Inspection of Automatic Sprinkler System

BE5 DSV East London Industrial
Development Zone

UNC.8480

09.05.2024 08:00 SAST

Photo 1

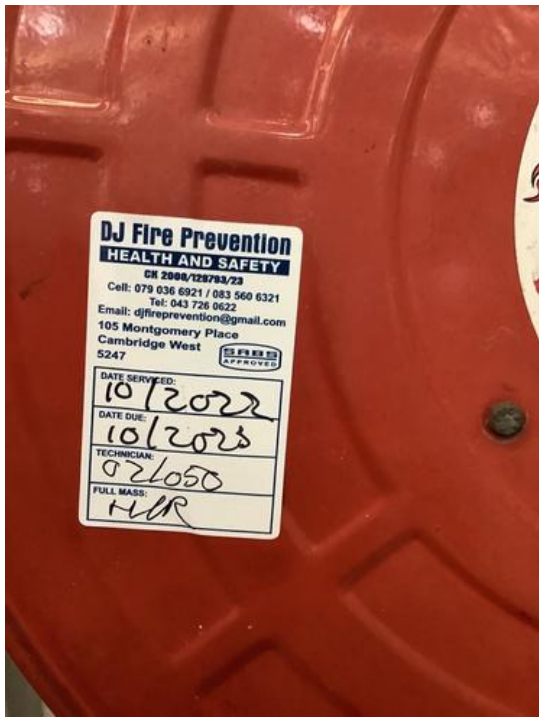
Clear access to the hand fire appliances must be maintained at all times.

Photo 16

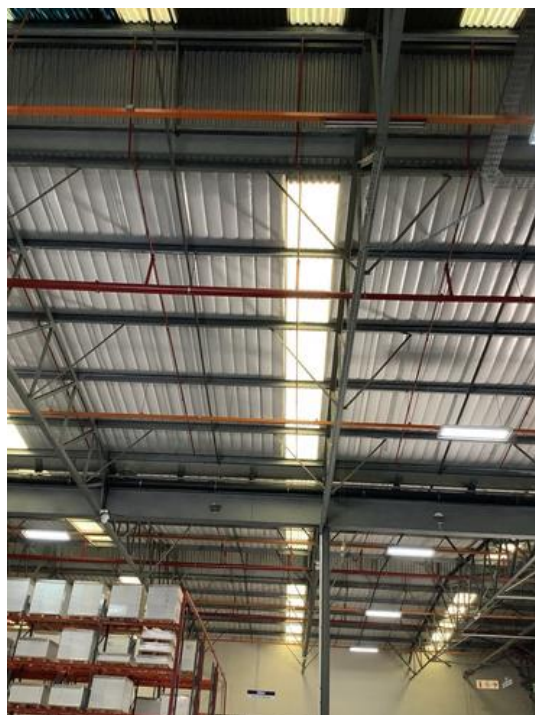
Sprinklers installed beneath open cell surfaces / translucent

sheeting.

All sprinklers located beneath open celled floors or stairwells and translucent sheeting must have approved water shields fitted above the sprinklers.
